The Woodlands Off-Site Sanitary Sewer Gravity Line B
Solicitation Number: CO-00660
Job No.: 22-1720

ADDENDUM 1
May 25, 2023

JOB NUMBER: SA190-0404.426
SHEET NO. C3.0

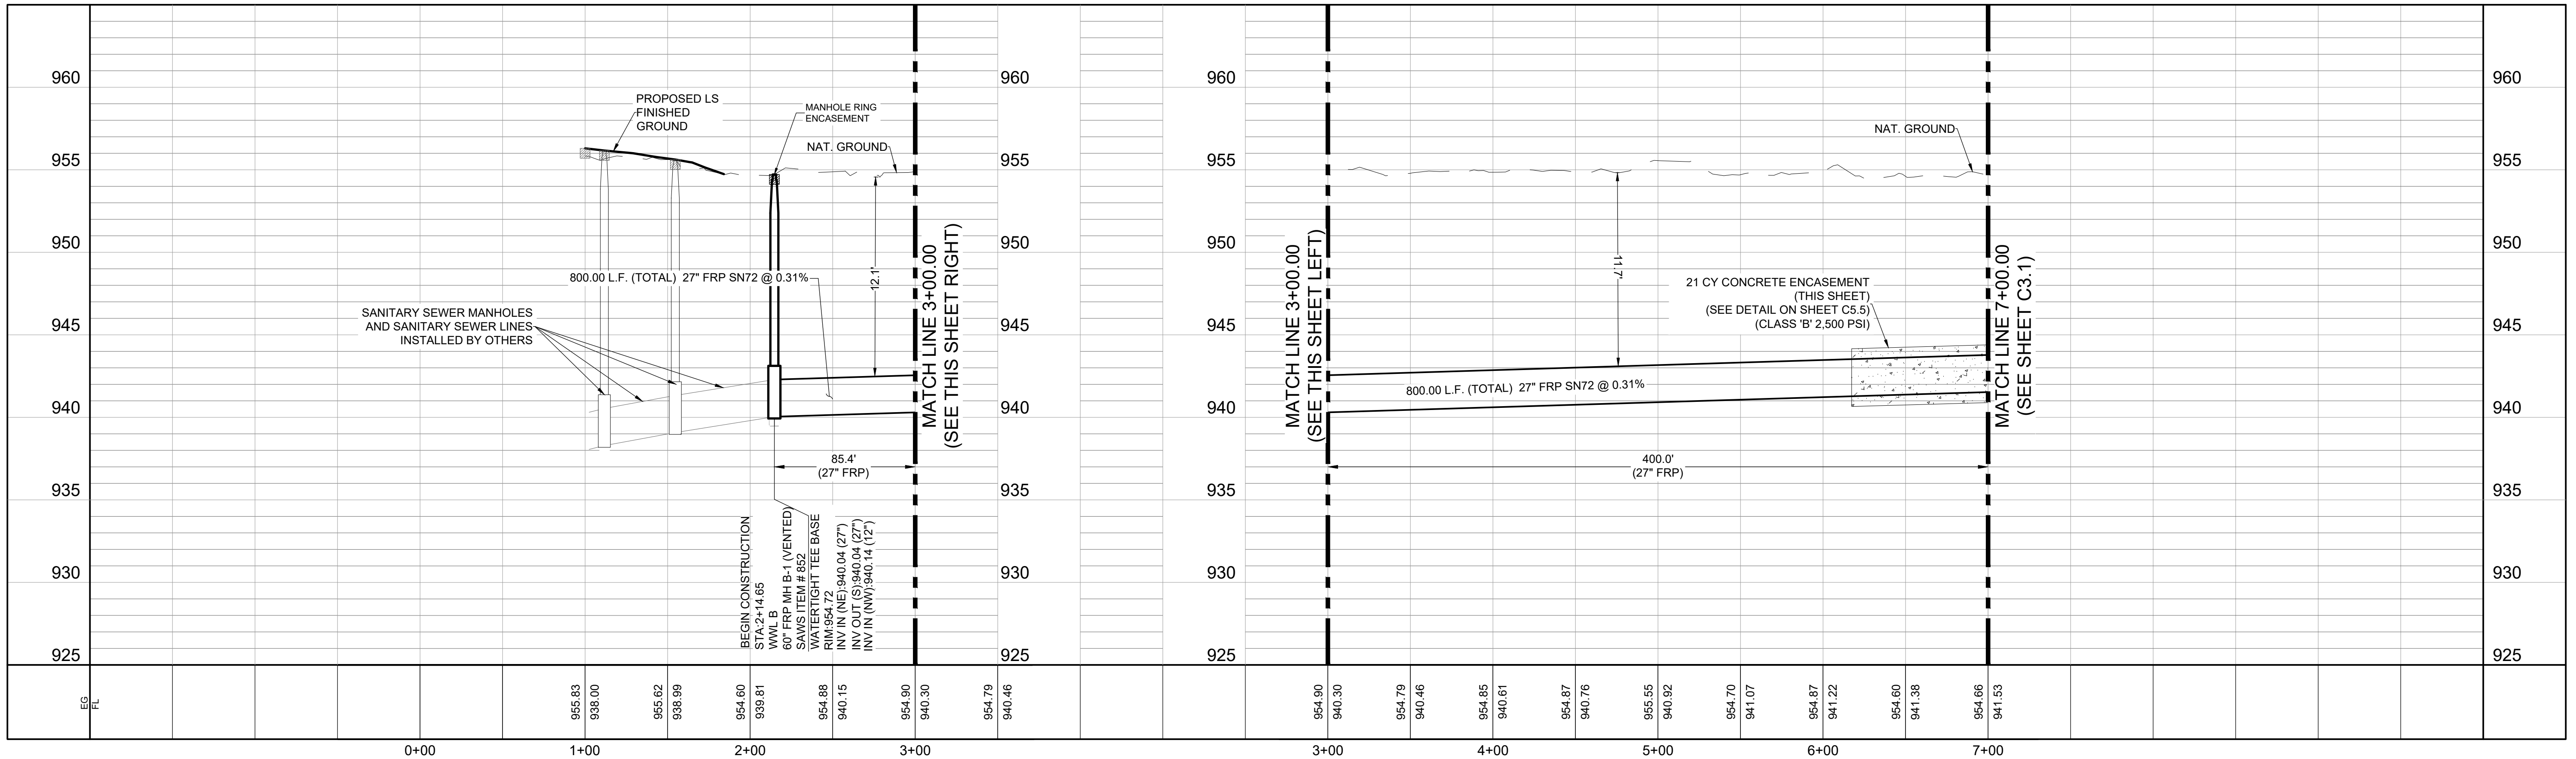
- 3. Question: Sheet C3.0 tie-in notes states that there is an existing sewer line and manholes. Can you add a bypass bid item and can you provide flows?**

Response: See Changes to the Plans #1. Sheet C3.0 has been revised to remove the reference to an existing sewer main. No bypass will be required as there is no existing sewer main associated with this project. The infrastructure previously shown as "existing" will be part of a separate, future project.

SHEET NO.
C3.2

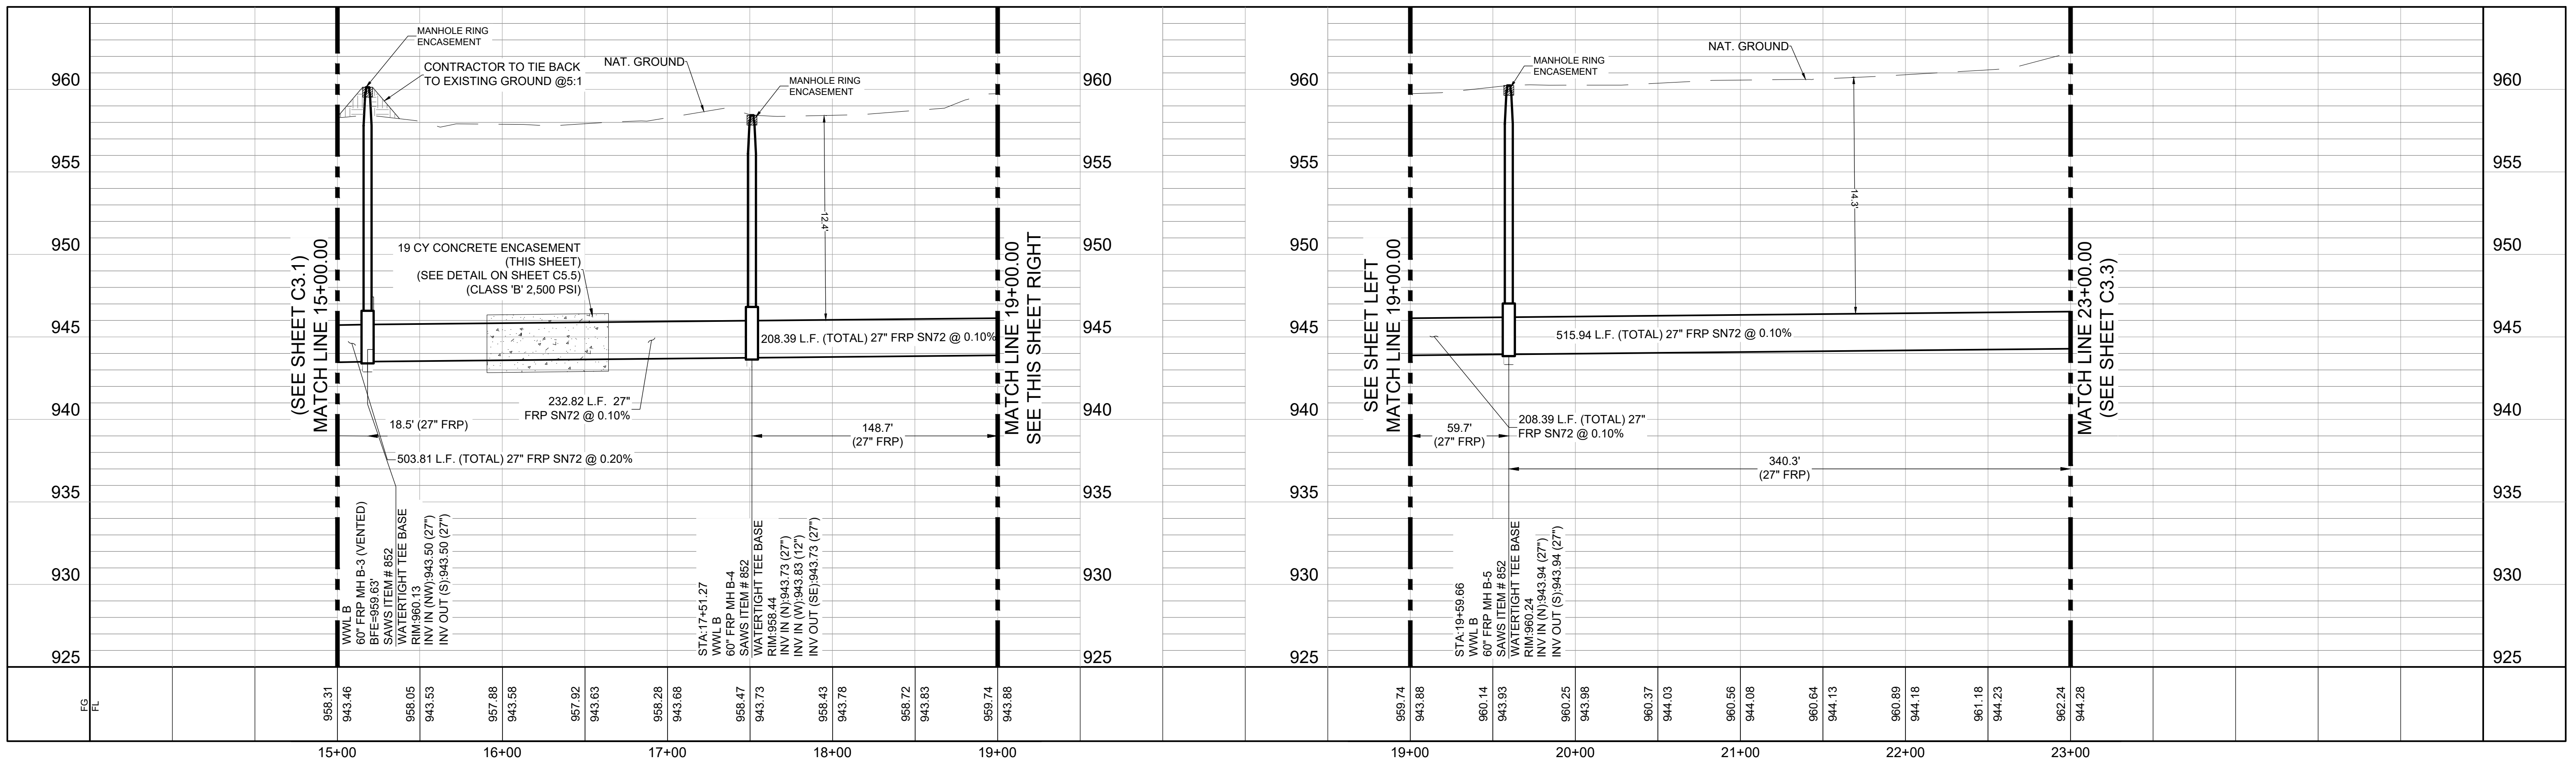
- 7. Question: There is a significant amount of footage of 27 inch pipe deeper than 16 feet from station 19-59 to station 38+70. Will a bid item be added for deeper elevations?**

18. Question: Please verify manhole quantities. It seems there are 7 manholes instead of the 6 listed in the proposal. Also, there seems to be 4 vented FRP manholes instead of the 5 listed in the proposal.

Response: See Changes to the Specifications #1 and Changes to the Plans #1. Both the Bid Proposal and sheets C3.0 through C3.7 have been revised to include a line item for 27" sewer main at 16'-20' depths.

Response: See Changes to the Specifications #1 and Changes to the Plans #1. Sheets have been updated to reflect the correct number of manholes.

SHEET NO.
C4.0

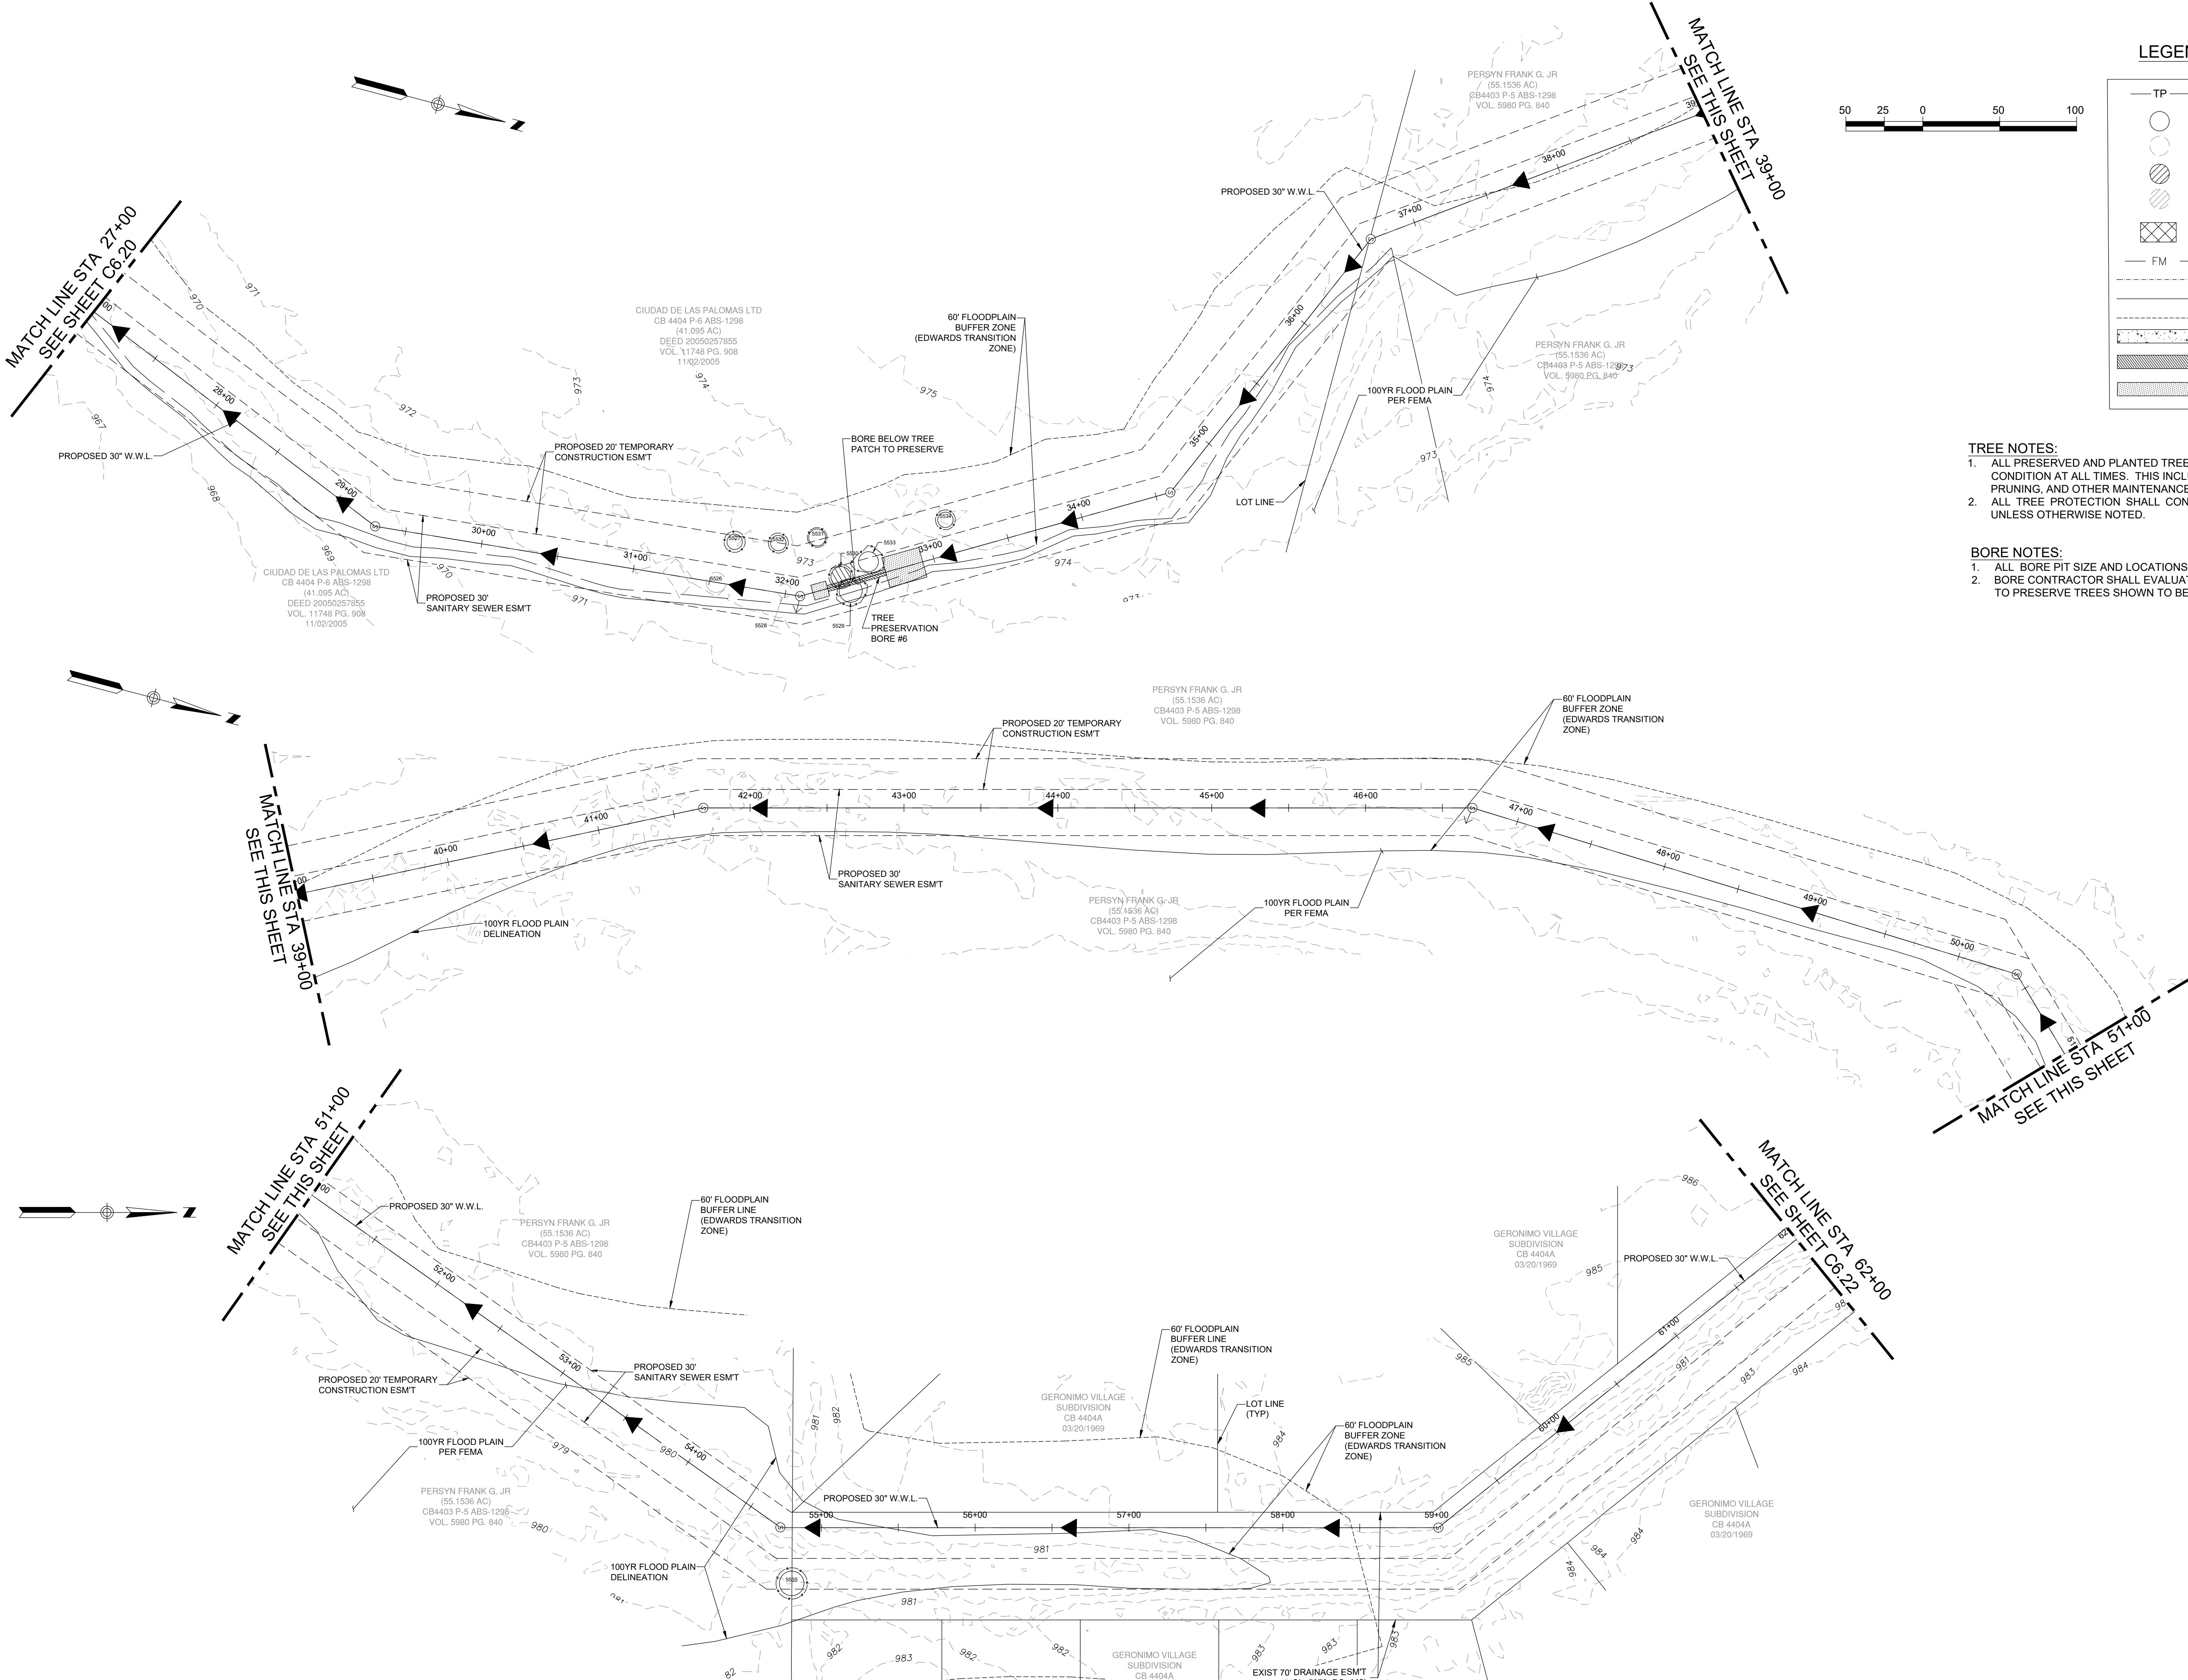
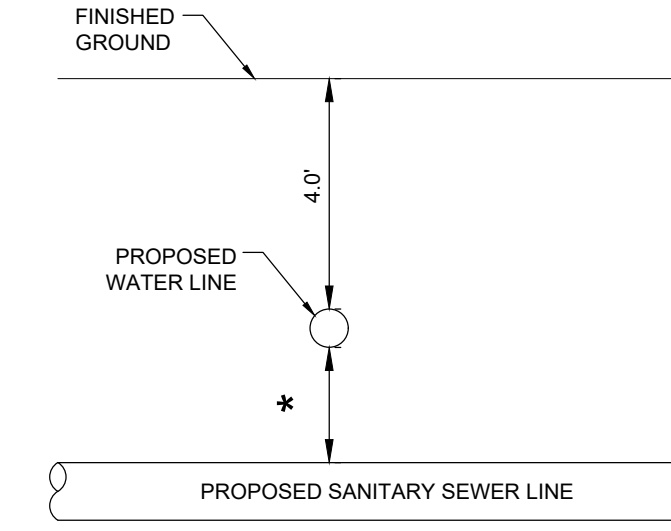
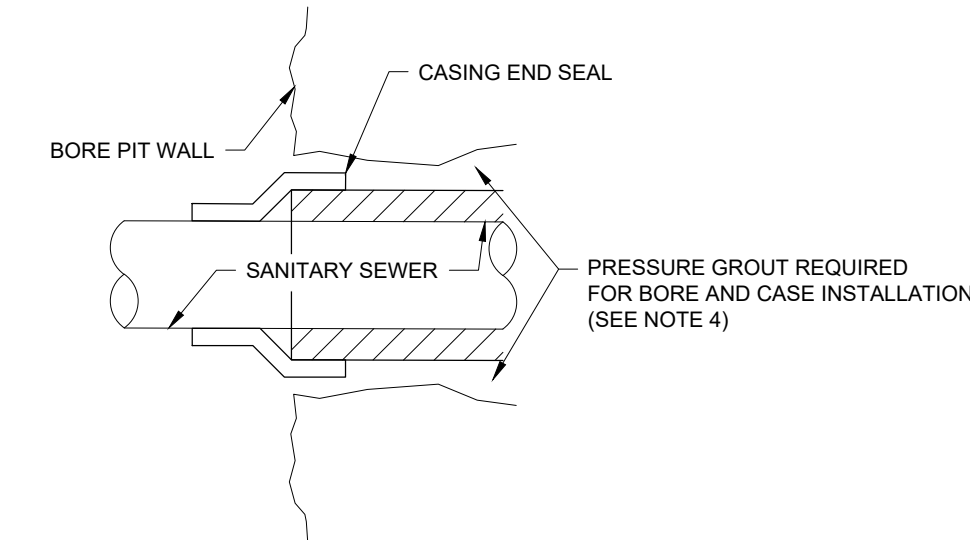
- 10. Question: Can a bid item be added for the carrier pipe for the tunnels and as per the detail on sheet C4.0, notes for annular void, it is stated not to fill the annular void inside the steel casing. Is this correct?**

- 14. Question: Can the missing tree preservation plan sheets be added?**
Response: See response to Question #9.
- 15. Question: To confirm information on sheet C4.0, we are only to grout the annular void between the casing and bore hole. We do not have to grout the annular space between the sanitary sewer pipe and the casing?**

17. Question: To confirm information on sheet C4.0, we need to contact grout the void between the bore hole and the casing via grout ports spaced every 10 feet. For a 48" casing that is doable and can be safely done. For the 24" casing, that is not standard procedure. It is unsafe to put someone in a 24" casing to hook up to the ports to pump the grout.

Response: Per SAWS spec item 856, the Jacking, Boring, or Tunneling line item is to include carrier pipe. See Changes to the Plans #2. The detail on sheet C4.0 has been revised to reference grouting between the steel casing and the carrier pipe.

Response: Per SAWS spec item 856.5.4, for sewer pipe the annular space between casing and carrier pipe shall be pressure grouted. See Changes to the Plans #2. The detail for the bore has been revised to properly reflect this specification.

Response: See Changes to the Plans #2. The notes on sheet C4.0 have been revised to remove the reference to grout ports. The method of grouting shall be left to the contractor to determine which is safest/most effective.
